**LEVY NUCLEAR POWER PLANT, UNITS 1 AND 2  
DOCKETS NOS. 52-029 AND 52-030  
RESPONSE TO REQUEST FOR ADDITIONAL INFORMATION LETTER NO. 016  
RELATED TO GENERAL CLIMATE**

Reference: Letter from Brian Anderson (NRC) to Garry Miller (PEF), dated March 4, 2009,  
"Request for Additional Information Letter No. 016 Related to SRP Section 2.3.1 for  
the Levy Nuclear Power Plant, Units 1 and 2 Combined License Application"

**Levy Nuclear Power Plant, Units 1 and 2  
Response to NRC Request for Additional Information Letter No. 016 Related to SRP  
Section 2.3.1 for the Levy Nuclear Power Plant, Units 1 and 2 Combined License  
Application, Dated March 4, 2009**

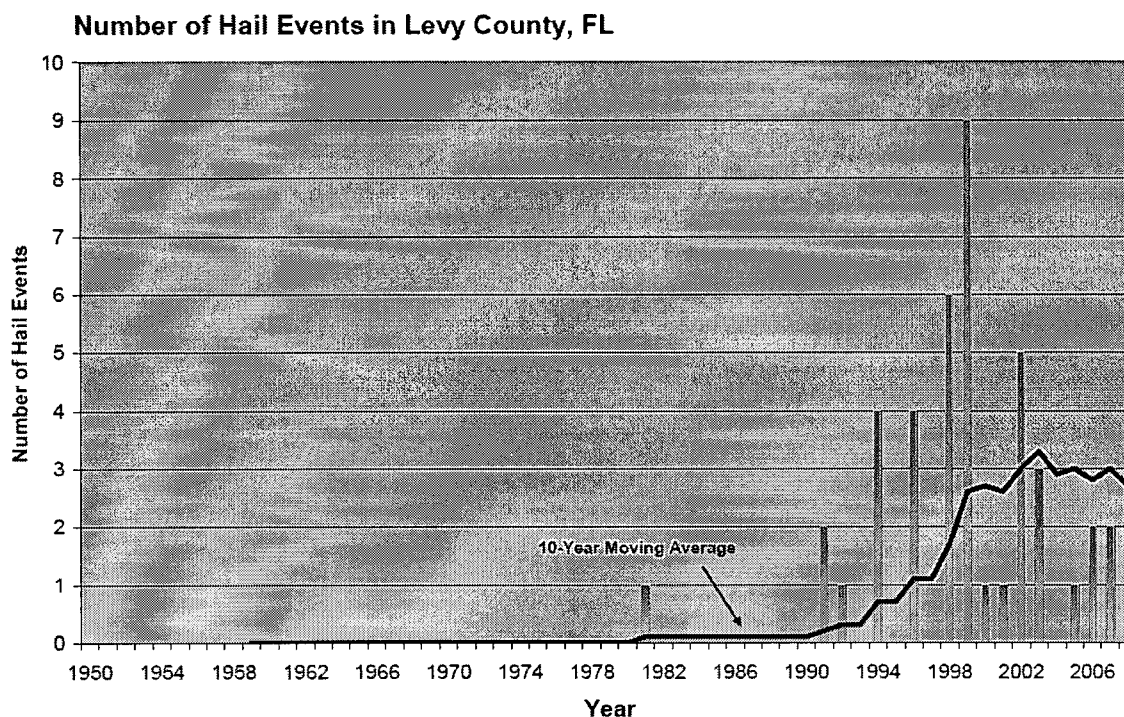
The Staff notes that in the NCDC Storm Events Database many severe weather reports are often incomplete or missing for older periods of record. The following graph shows the annual number of hail events that have occurred in Levy County, FL. Note the increase in the number of reported events during the more recent years in the attached graph.

Please revise FSAR Section 2.3.1.2.1 to account for this data deficiency, or provide an explanation why the data presented in Section 2.3.1.2.1 is accurate.

It is acknowledged that there has been an increase in the reported number of storm events over time, primarily as a result of increased reporting efficiency and confirmation skill and the possible overlooking of storms in the early years of data collection. Additionally, the increase in urbanization over the past 50 years has effectively resulted in an increase in the number of reported storms, if for no other reason than there are more targets damaged by hail and thunderstorms in an urban area than in a rural area. As a result, there is a higher frequency of reported incidents in urban areas than in rural areas. The same observation was made with regard to the reported occurrences of tornadoes, as described in FSAR Subsection 2.3.1.2.2 "Tornadoes and Severe Winds." Additional text providing this clarification will be included in FSAR Subsection 2.3.1.2.1 in a future amendment to the FSAR.

The third paragraph of FSAR Subsection 2.3.1.2.1 "Thunderstorms, Hail, and Lightning" will be revised from:

Severe thunderstorms producing hail events with hail greater than 1.9 cm (0.75 in.) or more in diameter were recorded during the period from 1950 to 2006. Forty hail events were reported in Levy County during the period from January 1, 1950, to March 31, 2007. Four storms resulted in reported property and crop damage. (Reference 2.7-013).

to:

Severe thunderstorms producing hail events with hail greater than 1.9 cm (0.75 in.) or more in diameter have been recorded since 1950. Forty-five events were reported in Levy County during the period from January 1, 1950, to November 30, 2008. Four storms resulted in reported property and crop damage (Reference 2.7-013). The number of reported hail events has increased significantly over time, primarily as a result of increased reporting efficiency and confirmation skill and the possible overlooking of storms in the early years of data collection. Additionally, the increase in urbanization over the past 50 years has effectively resulted in an increase in the number of reported storms, if for no other reason than there are more targets damaged by hail and thunderstorms in an urban area than in a rural area. As a result, there is a higher frequency of reported storms in urban areas than in rural areas. While 45 hail storms were reported in Levy County over the period of 1950 to 2008, the more recent storm reports (Reference 2.3-209) indicate that there is a greater frequency of reported storms in more recent years.
